Amendment 5

RFQ# 1232SA26Q0361 - Remove Walk-in Cooler located in B1, SB46 (Athens, GA)

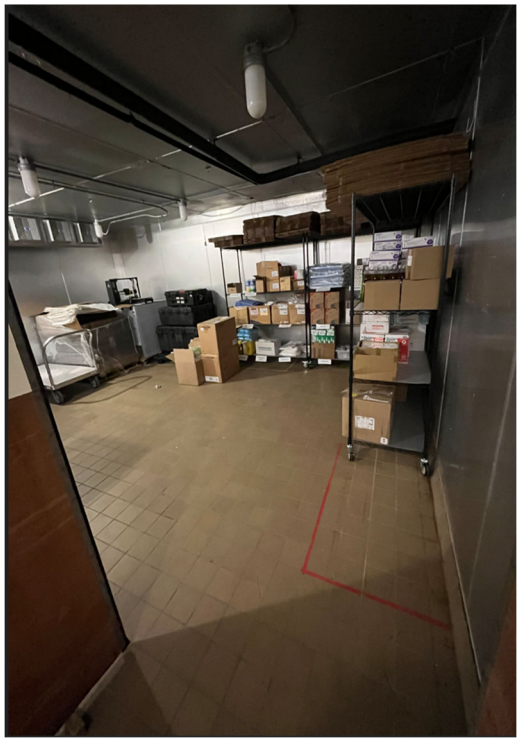
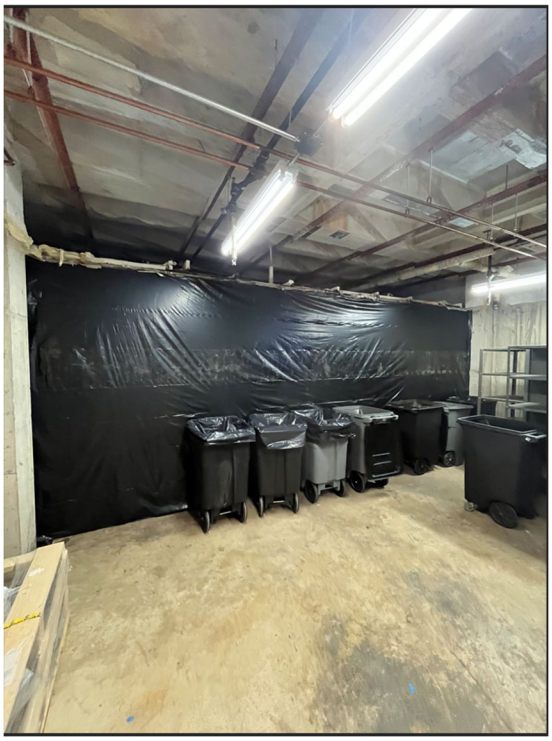
1. Would USDA be able to provide:
   - Dimensions of the existing walk-in cooler
     Answer: the rough dimensions are 23'x 21'
   - Manufacturer/model information (if available)

Answer: Unknown.
   - Photos of the existing unit:
     Answer: see below
   - Confirmation whether associated compressor/condenser equipment is included in the removal scope
